UNITED STATES PATENT AND TRADEMARK OFFICE

APPLICATION NO.	FILING DATE	FIRST NAMED INVENTOR	ATTORNEY DOCKET NO.	CONFIRMATION NO.
10/750,380	12/29/2003	Jeffrey S. Hovland	2316.1646US01	4932
7590	05/15/2006		EXAMINER	
Merchant & Gould P.C. P.O. Box 2903 Minneapolis, MN 55402-0903				ROJAS, OMAR R
			ART UNIT	PAPER NUMBER
				2874

DETAILED ACTION

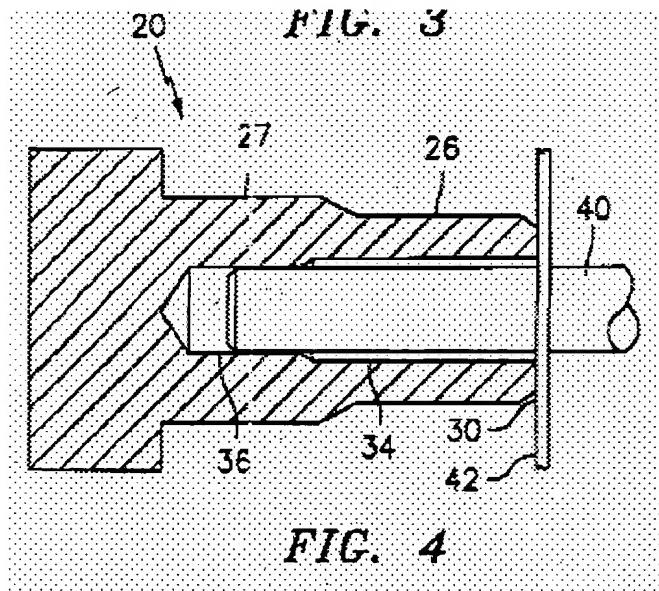
Regarding claims 16, 23, and 24, Ott discloses a fiber optic connector assembly (e.g., Fig. 4) comprising:

a fiber optic connector 42 mounted to an end of and terminating a fiber optic cable and a ferrule 40 holding an optical fiber from the cable, the ferrule including a end face; a plug/dust cap 20 configured to fit about and engage the ferrule 40 of the fiber optic connector, the dust cap 20 positioned about and engaging the ferrule to seal the end face from air-borne particles. Figure 4 of Ott is reproduced below.

Regarding claim 26, the shoulder 25 of Ott corresponds to the recited finger hold.

Thus, Ott only differs from claims 16, 23, 24, and 26 in that Ott does not teach an adhesive tape/cover for holding the dust cap 20 to the connector 42, a center portion of the adhesive tape releasably attached to the dust cap 20 and first and second end portions of the adhesive tape releasably attached to the fiber optic connector 42.

In view of the Ott invention, one of ordinary skill in the art would have wanted to use releasable adhesive tape in order to provide additional securement of the dust cap 20 to the connector 42, i.e., by "sticking" them together. Wrapping the adhesive tape in the manner prescribed by claim 24 would be a simple and obvious method of better securing the dust cap 20 to the connector 42 in Ott using adhesive tape.

FIG. 5

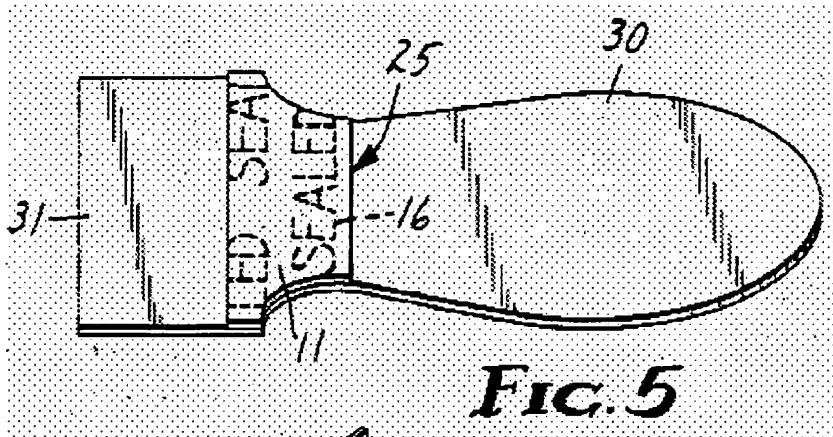
Regarding claims 25 and 27, the previous remarks above concerning Ott are incorporated herein. The invention of claims 23 and 24 has been shown to be obvious in view of Ott. Ott further differs from claims 25 and 27 in that Ott does not disclose tape having an anti-tamper feature or tape having a tail to facilitate removal as recited by claims 25 and 27, respectively. Schaefer, on the other hand, discloses an adhesive tape 25/30 having an anti-tamper feature 11/16 and a tail 31 to facilitate removal. See column 4, lines 7-28 of Schaefer. Fig. 5 of Schaefer is reproduced below.

One motivation for combining Schaefer with Ott is to provide an anti-tamper mechanism for Ott's dust cap 20. For example, if a small child were to gain access to the dust cap 20 of Ott, the child could pull off the dust cap from the ferrule 40 possibly exposing the ferrule end face to contaminants. By combining the anti-tamper adhesive tape 25/30 of Schaefer with Ott, such antics could be prevented. Therefore, it would have been obvious to one of ordinary skill at the time of the claimed invention to obtain the invention specified by claims 25 and 27 in view of Ott combined with Schaefer.
